NVM Express Technical Proposal for New Feature

Technical Proposal ID	6005 – NVMe 1.3 Alignment
Change Date	11/18/2018
Builds on Specification	NVM Express Management Interface 1.0a

This proposal is to align the NVMe-MI specification with the NVMe 1.3 specification addressing the following items:

Figure 2: Single-Port PCIe SSD

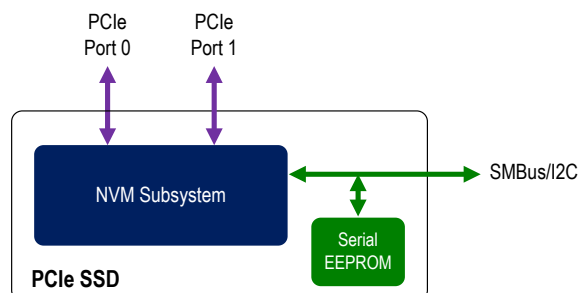
Figure 2 illustrates an NVMe Storage Device that is a single-port PCIe SSD with the FRU Information Device implemented by the NVM Subsystem. Figure 3 illustrates an NVMe Storage Device that is a dual-port PCIe SSD with an SMBus/I2C port and a FRU Information Device implemented using a Serial EEPROM.
